Further Information for Sites Proposed for Allocation in the Waste Plan

Waste Sites Proposed for Allocation in the Bournemouth, Dorset and Poole Waste Plan	
Site Name and reference:	Inset 1 – Woolsbridge Industrial Estate, Three Legged Cross
Proposed uses:	Waste transfer and/or the transfer or treatment of bulky waste
Lead Local Flood Authority comments:	<p><u>NB: Comments received below based on a larger area of land considered in the 2015/16 Waste Plan. The land proposed for allocation is referred to as the southern parcel of land.</u></p> <p>Elements of both the northern and southern sites (but especially the northern) fall within Flood Zones 2 & 3 (medium & high risk of fluvial flooding). Equally there is some indication of surface water flooding during extreme rainfall events (1:100/1000yr). The sites are given as 7.42 and 5.54 ha in area, and so would / do represent major development for which our involvement and consultation as LLFA would be necessary. Indeed we (DCC/FRM) were consulted by EDDC in respect of an Outline application in June 2015 (ref: 3/15/0556). This application related only to access and scale (our ref: PLN15-008), to which we raised no objection, subject t

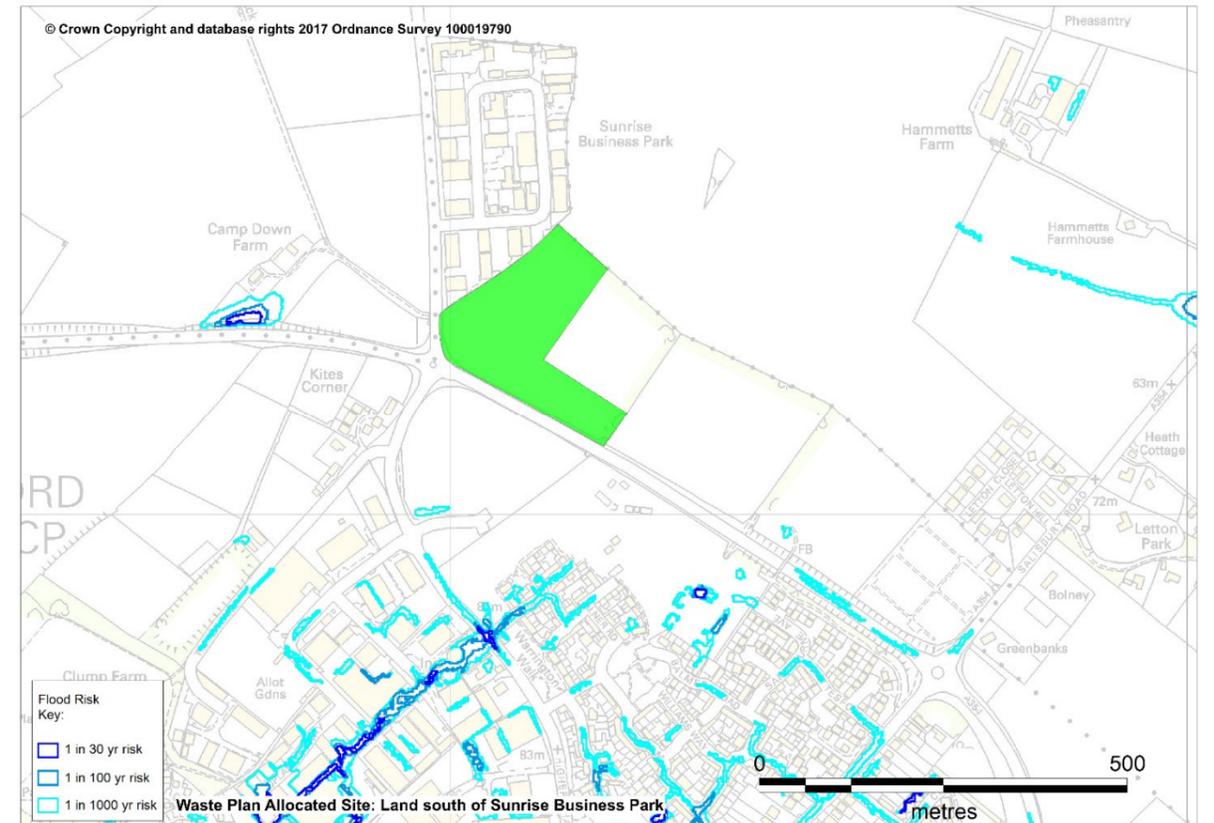
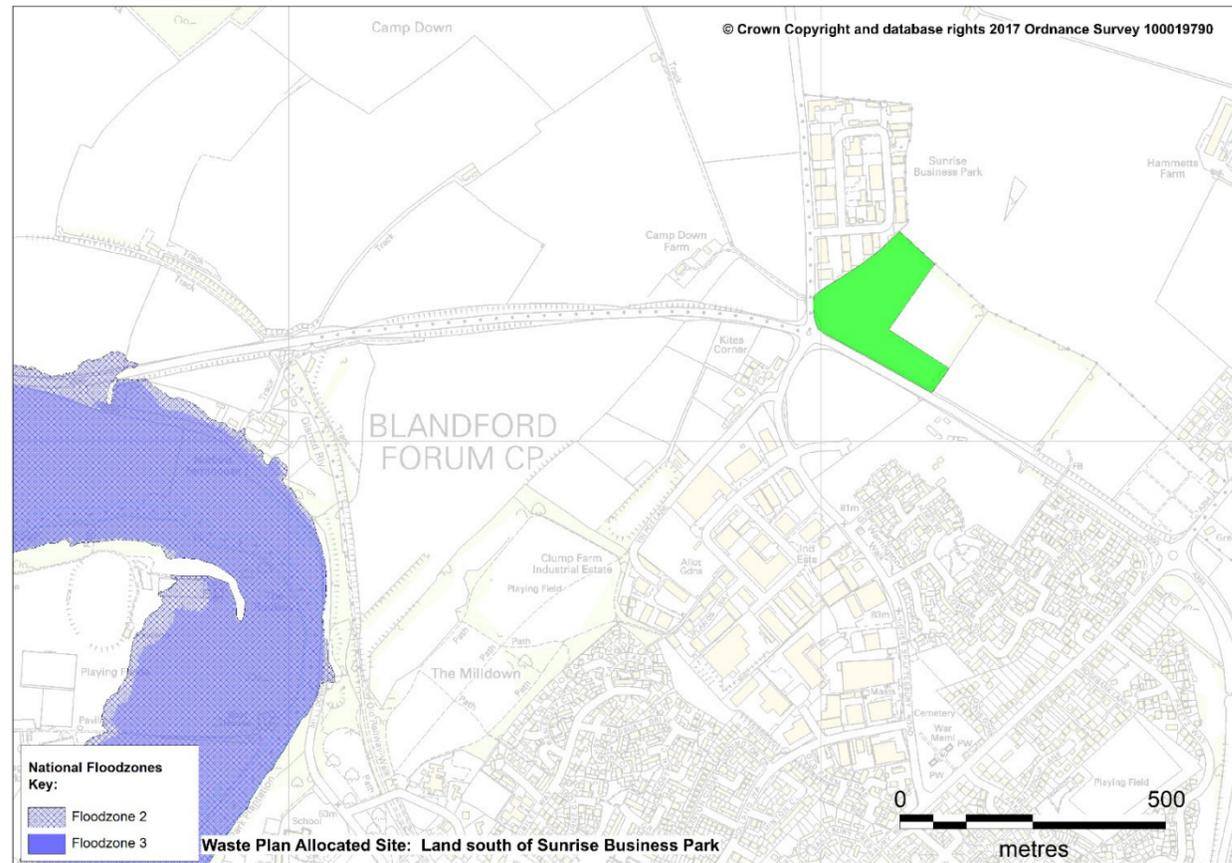
Site Name and reference:	Inset 2 – Land south of Sunrise Business Park, Blandford
Proposed uses:	Waste management centre
Lead Local Flood Authority comments:	<u>NB These comments relate to the larger site considered in the 2015/16 Draft Waste Plans</u> The site is entirely within Flood Zone 1 (low risk of fluvial flooding), and is not thought to be at theoretical risk of surface water flooding. Given that the site area is 5.3 ha any development proposals are likely to be considered as major, for which our involvement and consultation as LLFA would be necessary with regard to surface water management. The necessary consideration of surface water management will need to comply with current guidance and the requirements of the NPPF, to ensure both that the site is protected and that no off-site worsening results. We are in agreement with the EA's previous input, but suggest that DCC as LLFA are identified as the lead in terms of surface water management.

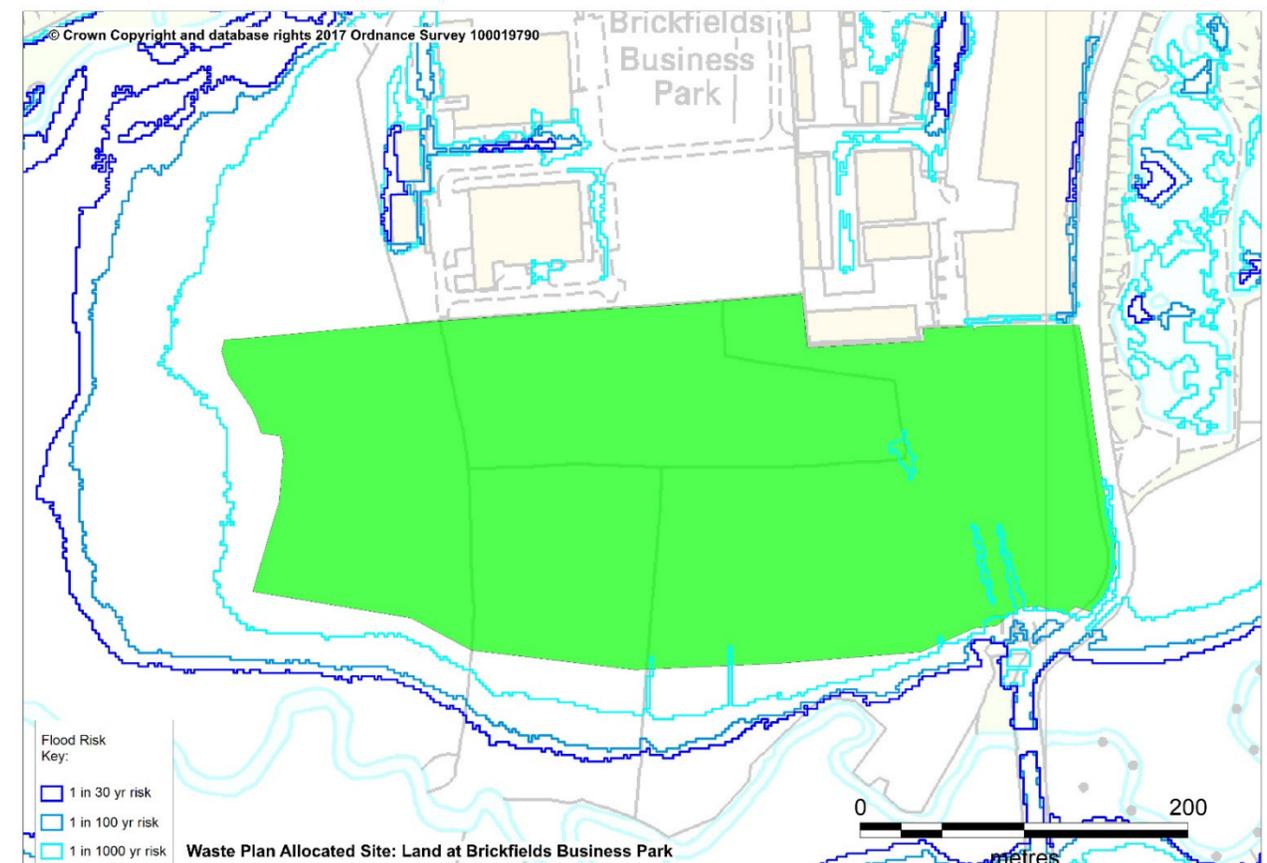
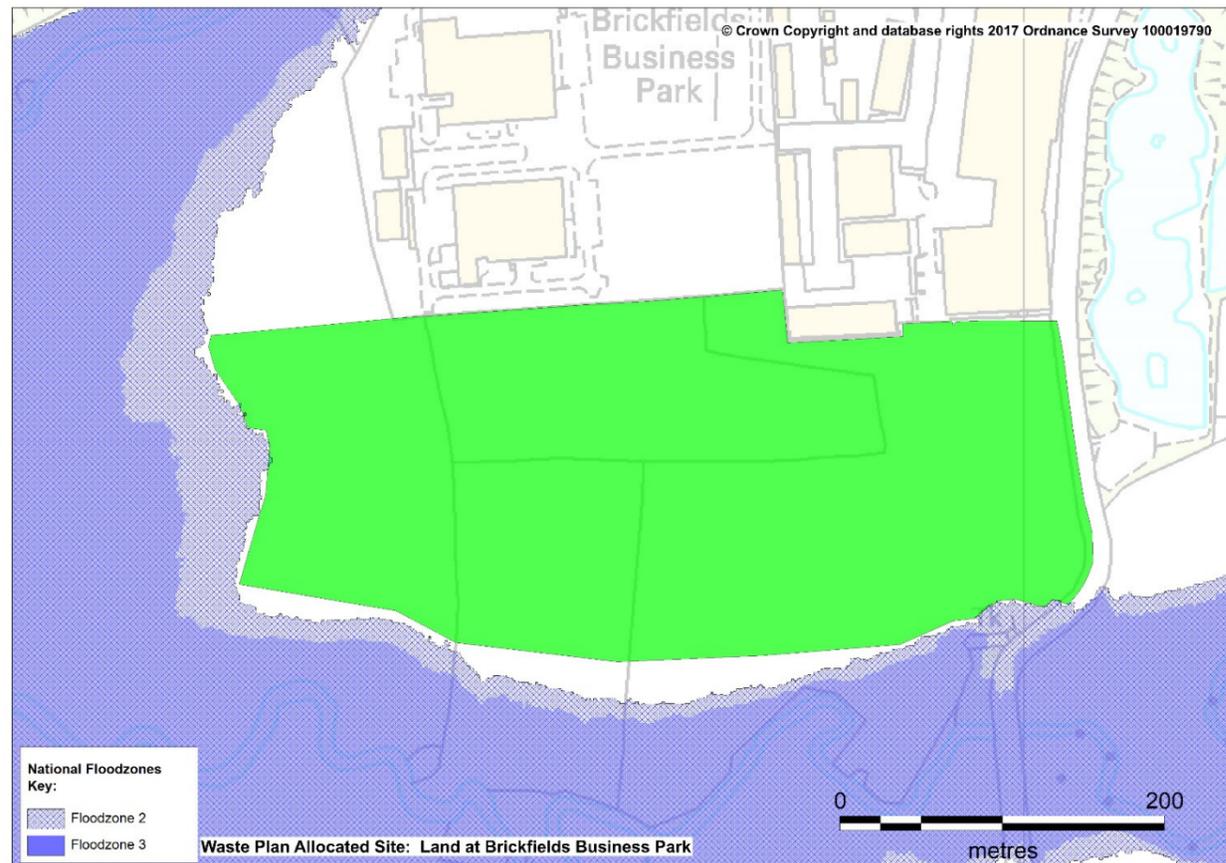
Site Name and reference:	Inset 3 – Brickfields Business Park, Gillingham
Proposed uses:	Household Recycling Centre Waste Vehicle Depot
Lead Local Flood Authority comments:	<u>NB: Comments below made on the slightly larger area of land contained in the 2015/16 Draft Waste Plan</u> Elements of the (larger) site fall within Flood Zones 2 & 3 (medium & high risk of fluvial flooding) to the west and south, in proximity to the adjacent Main River/s Stour and Lodden. The (larger) site is thought to be equally at risk from surface water flooding during extreme rainfall events (1:100/1000yr). The (larger) site area is given as 11 ha, although only 1-1.5 ha is likely to be allocated to the proposed use. However this site area and a potential depot footprint of between 0.3-0.5 ha would represent major development, for which our involvement and consultation as LLFA would be necessary. The necessary consideration of surface water management will need to comply with current guidance and the requirements of the NPPF, to ensure both that the site is protected and that no off-site worsening results. We are in agreement with the EA's previous input, but suggest that DCC as LLFA are identified as the lead in terms of surface water management. Any works to the adjacent Main River/s Stour and Lodden, or associated floodplain (Flood Zone) will require Flood Defence Consent (FDC) from the EA.

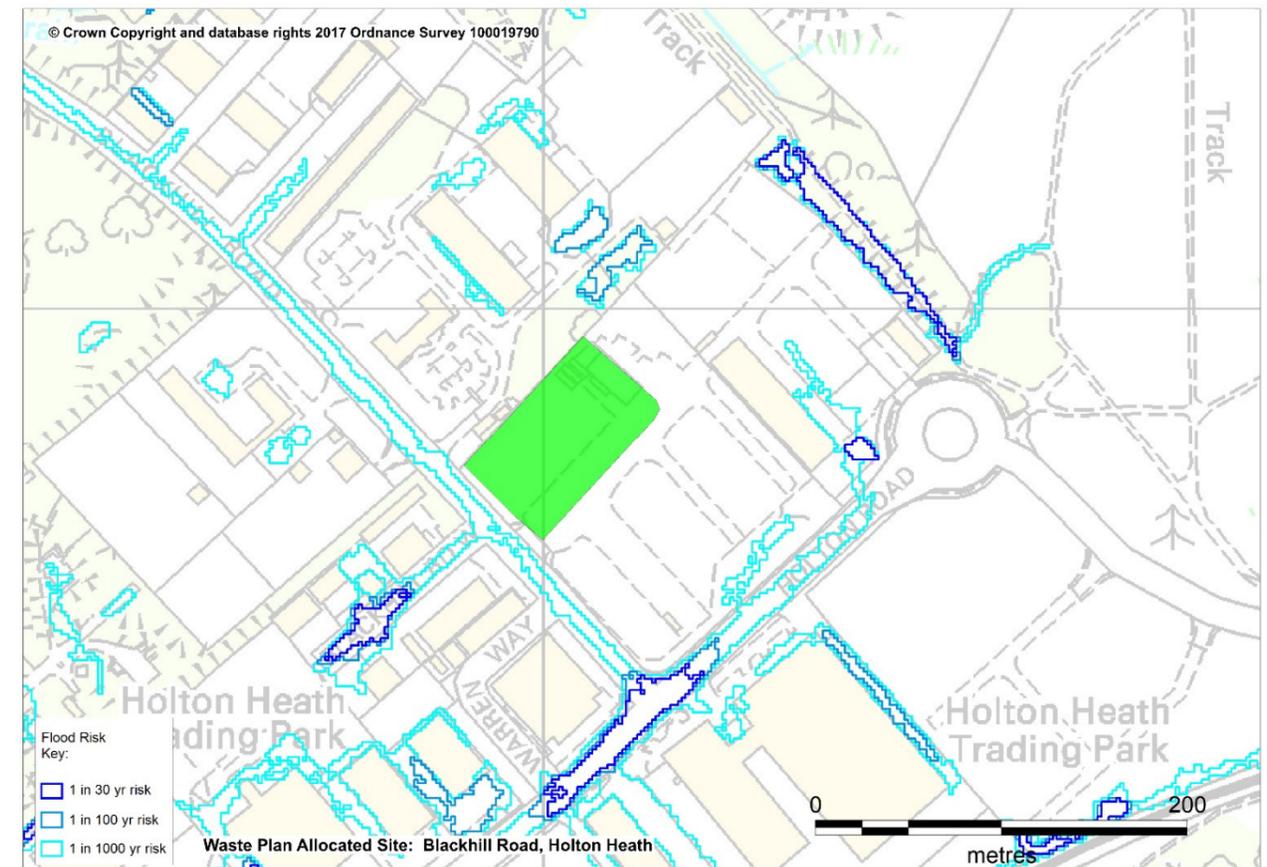
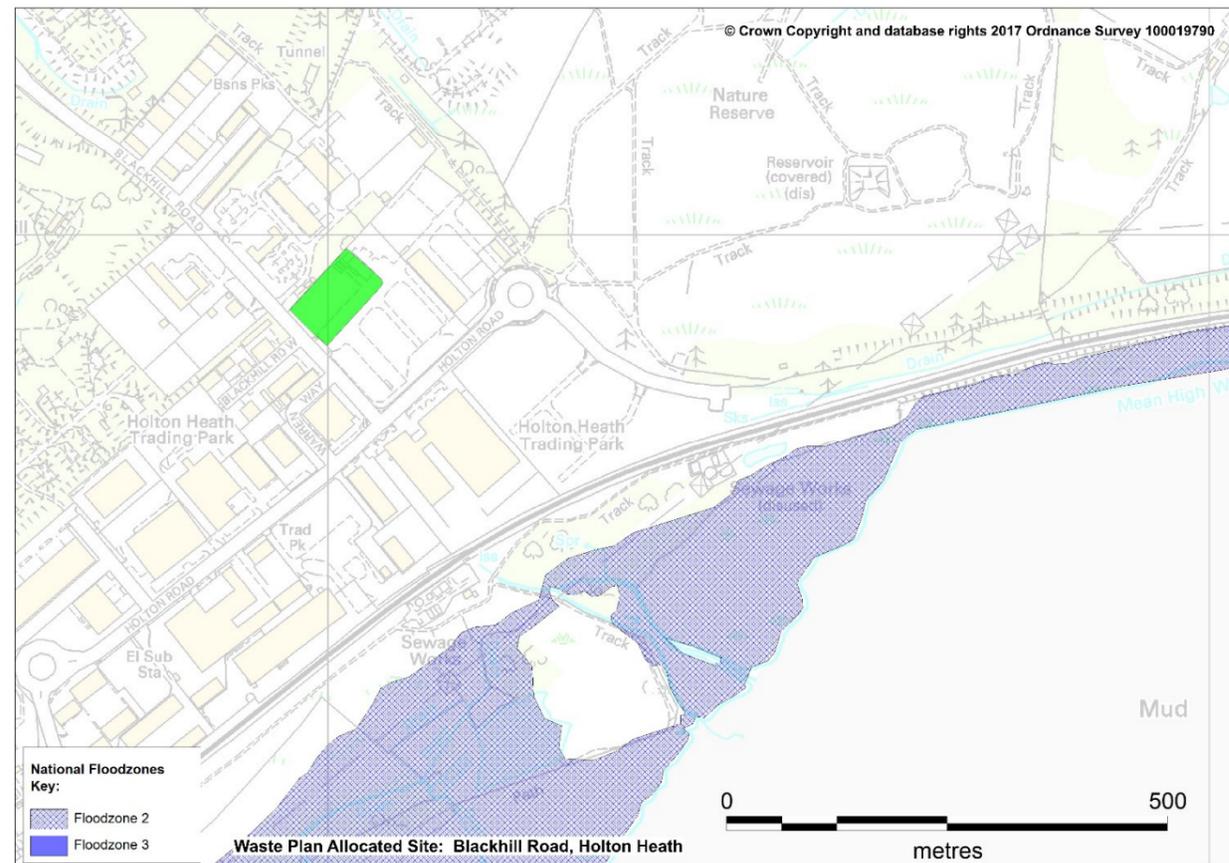
Site Name and reference:	Inset 4 – Land at Blackhill Road, Holton Heath Industrial Estate
Proposed uses:	Waste Transfer Station Waste Vehicle Depot
Lead Local Flood Authority comments:	The site is entirely within Flood Zone 1 (low risk of fluvial flooding), and is not thought to be at theoretical risk of surface water flooding. Given that the site area is given as only 0.5 ha, any subsequent consultation with DCC as relevant LLFA would be on the basis of building footprint, if greater than 1000m2 (i.e. major). The necessary consideration of surface water management will need to comply with current guidance and the requirements of the NPPF, to ensure both that the site is protected and that no off-site worsening results. We are in agreement with the EA's previous input, but suggest that DCC as LLFA are identified as the lead in terms of surface water management, should the subsequent proposals represent major development.

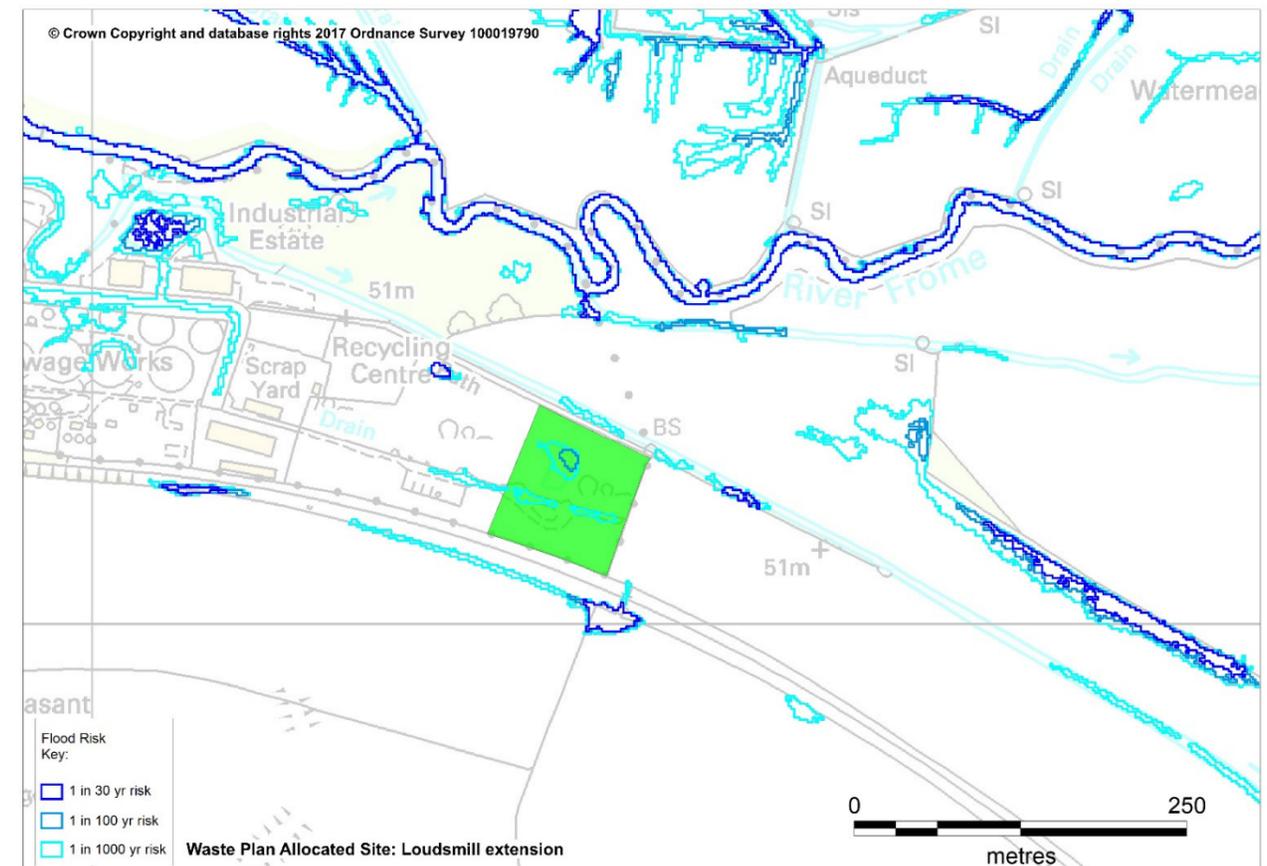
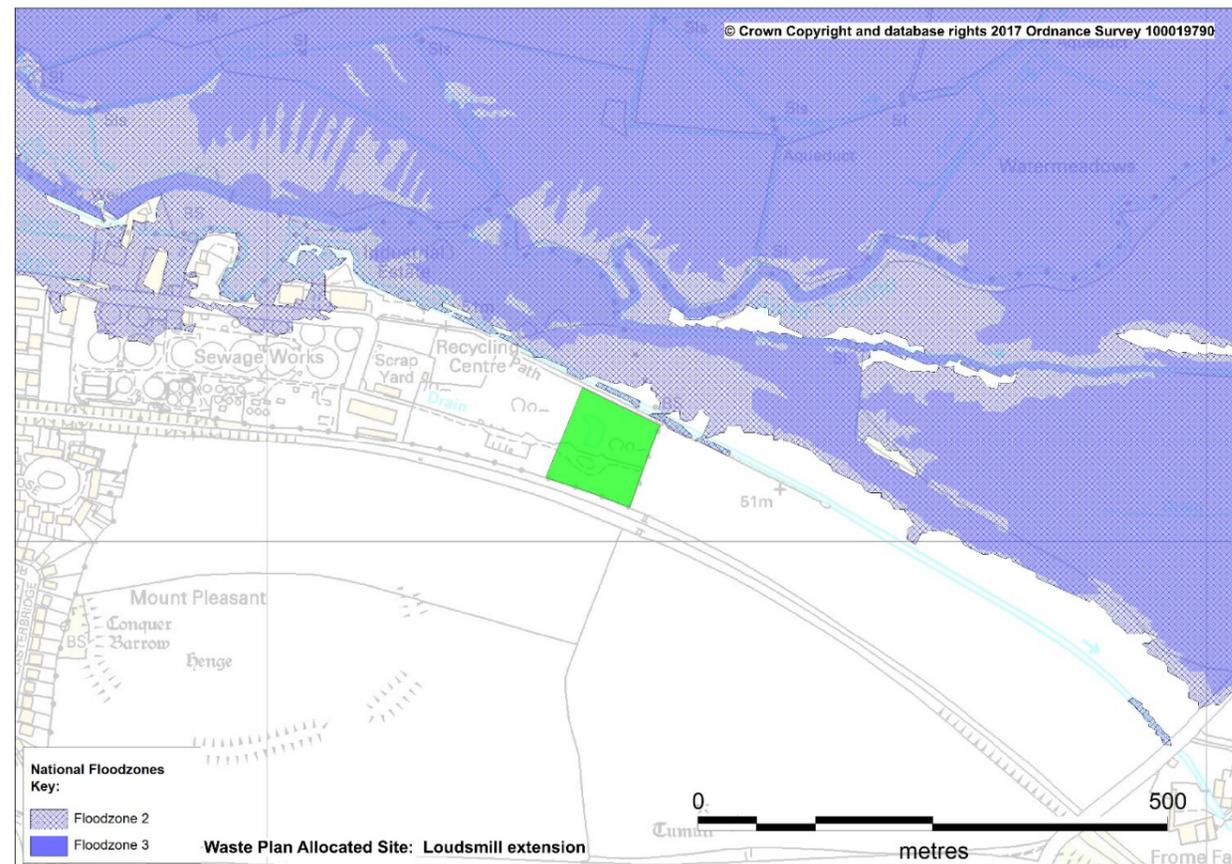
Site Name and reference:	Inset 5 – Loudsmill, Dorchester
Proposed uses:	Household Recycling Centre
Lead Local Flood Authority comments:	<p><u>NB: Comments based on wider area of land included in 2015/16 Draft Waste Plans.</u></p> <p>The site shown falls marginally within Flood Zones 2 (medium risk of fluvial flooding) along the northern boundary of the existing Wessex Water compound. The site is equally thought to be at risk from surface water flooding during extreme rainfall events (1:1000yr). The site area is given as 3.44 ha and would therefore represent major development, for which our involvement and consultation as LLFA would be necessary, unless sub-divided. The necessary consideration of surface water management will need to comply with current guidance and the requirements of the NPPF, to ensure both that the site is protected and that no off-site worsening results. We are in agreement with the EA's previous input, but suggest that DCC as LLFA are identified as the lead in terms of surface water management. Any works to the adjacent Main River Frome, or associated floodplain (Flood Zone 2), is likely to require Flood Defence Consent (FDC) from the EA.</p>
